# SERVICE BULLETIN

Service Bulletin Number:		nber:	SB05147	
Revision:	В	2 and 3. B: Replac 2. Revise	ase reference "note" to instructions. Added figures ced photos figure 2 and 3 with illustration figure ed A(6) and B(6) to refer to figure 2. Deleted B(7) requiring DASC completion form	Page: 1

## TITLE: LEG REPLACEMENT

Fig 1 Leg Replacement

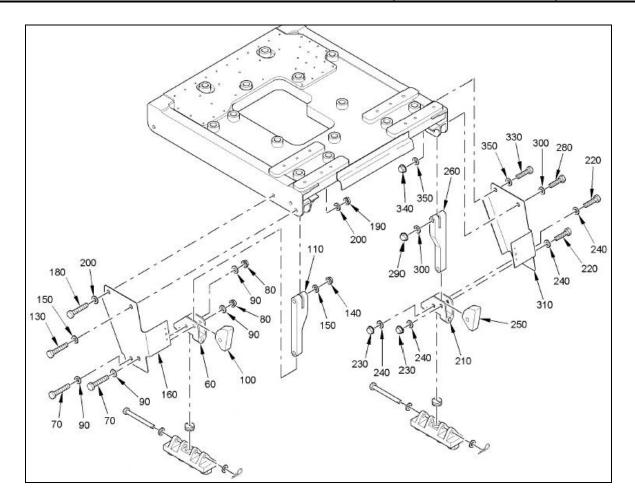
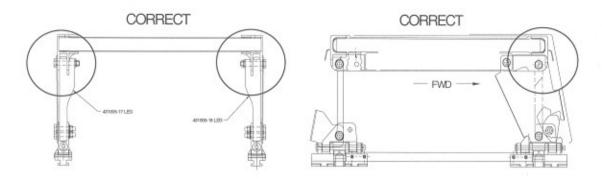
The lot of material used to manufacture the forward pedestal legs are suspect. Replacement ensures the seat meets the approved data package.

This service bulletin incorporates a pedestal leg replacement. Replacement is **mandatory** and must be completed within one year of the date of this Service Bulletin.

- 1. Remove bolts (70), (130), (180), washers (90), (150), (200), nuts (80), (140), (190) and remove gusset (160).
- 2. Remove and discard leg (110) and install leg 431005-17.

- 3. Reinstall hardware removed in steps 1 & 2 in reverse order of removal.
- 4. Remove bolts (220), (280), (330), washers (240), (300), (350), nuts (230), (290), (340) and gusset (310).

- 5. Remove and discard leg (260) and install leg 431005-18.
- 6. \*Reinstall hardware removed in steps 4 & 5 in reverse order of removal.
  - **\*NOTE**: See Figure 2. Remove the pedestal shroud. Examine the two solid aluminum legs that are in the forward position relative to the aircraft. The legs are installed CORRECTLY if the length of the slot on the top of the leg is *shorter on the forward side* as compared to the length of the slot on the aft side of the leg. The legs are installed INCORRECTLY if the length of the slot on the top of the leg is *longer on the forward side* as compared to the length of the slot on the slot on the slot on the slot on the top of the leg is *longer on the forward side* as compared to the length of the slot on the slot

- 1. Remove bolts (70), (130), (180), washers (90), (150), (200), nuts (80), (140), (190) and remove gusset (160).
- 2. Remove and discard leg (110) and install leg 431005-18.
- 3. Reinstall hardware removed in steps 1 & 2 in reverse order of removal.
- 4. Remove bolts (220), (280), (330), washers (240), (300), (350), nuts (230), (290), (340) and gusset (310).
- 5. Remove and discard leg (260) and install leg 431005-17.
- 6. \*Reinstall hardware removed in steps 4 & 5 in reverse order of removal.
